2017/18 Annual Report of the Ground-Level Monitoring Committee

*FINAL REPORT
NOVEMBER 2018*

Appendix B - Response to GLMC Comments

Figure 3-1b

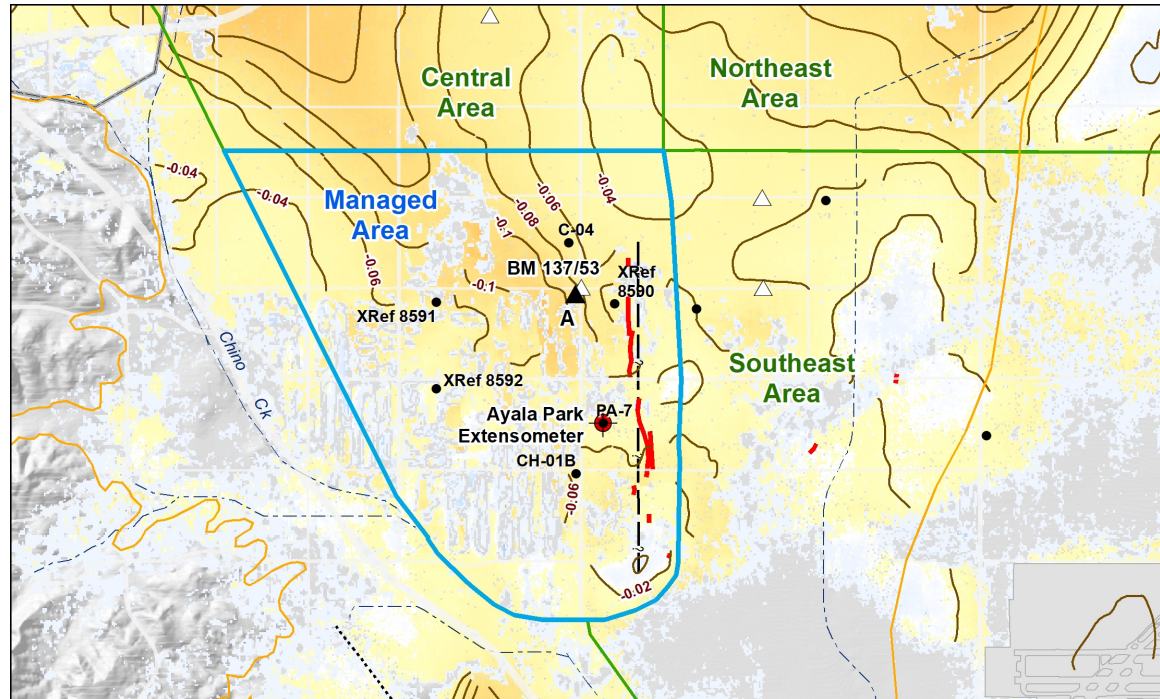
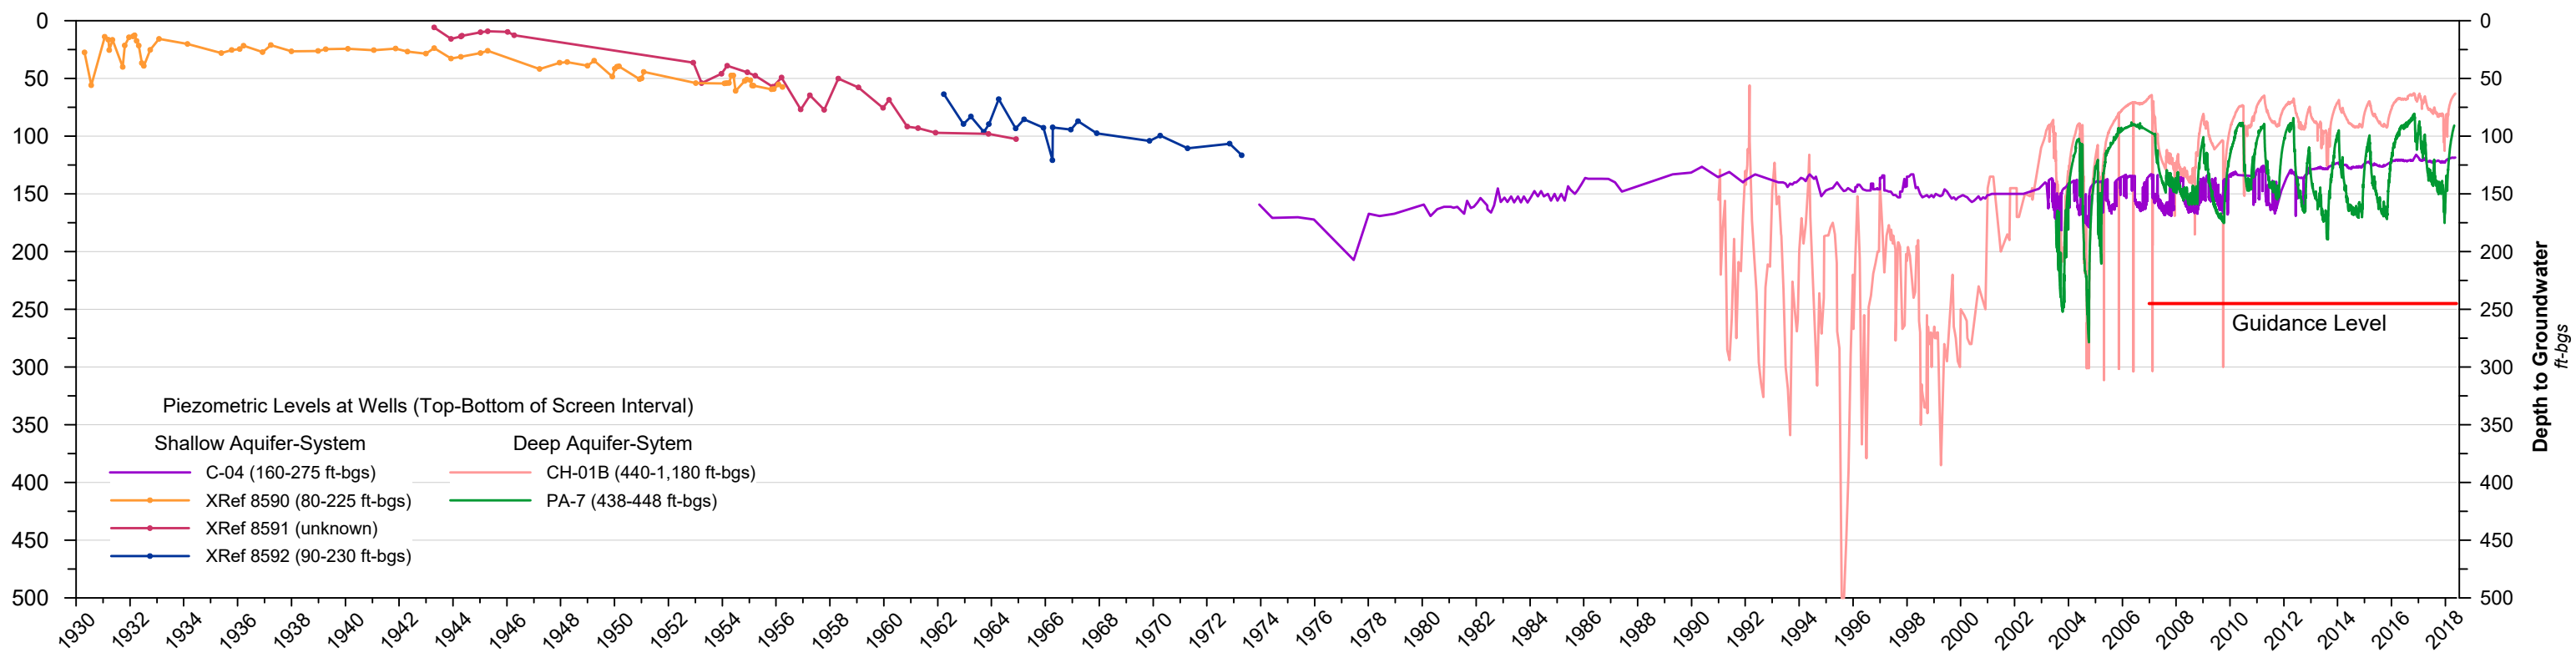
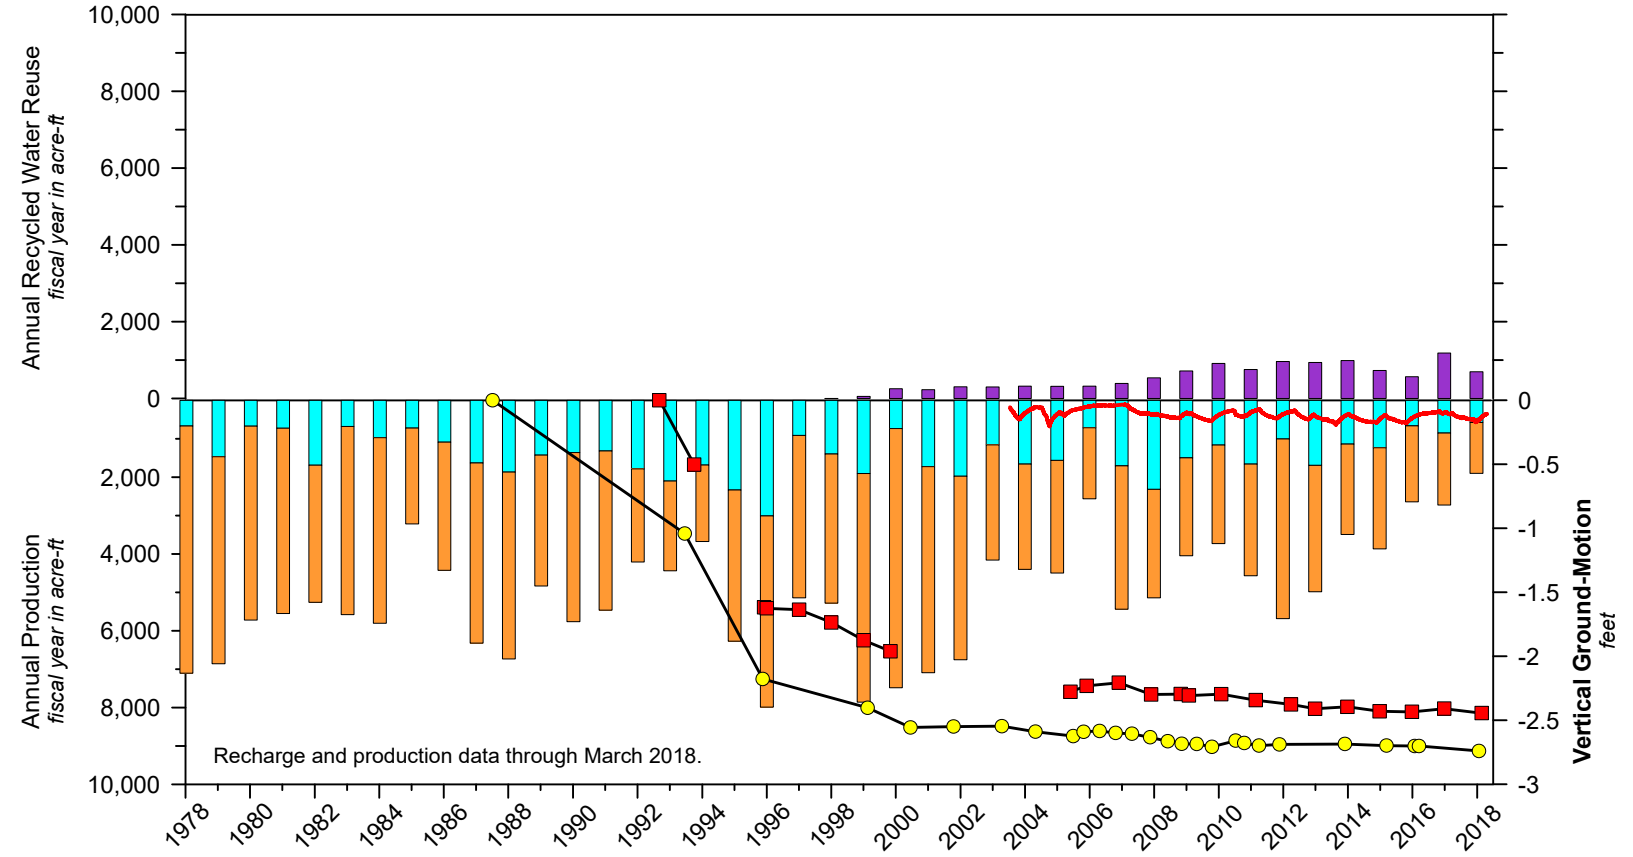
Comment 1 – Figures 3-1b and 3-7b

Text has been added to Section 3.2: “Figure 3-7b shows an isolated area of downward vertical ground motion located southwest of the intersection of Highway 71 and Soquel Canyon Parkway. The area of
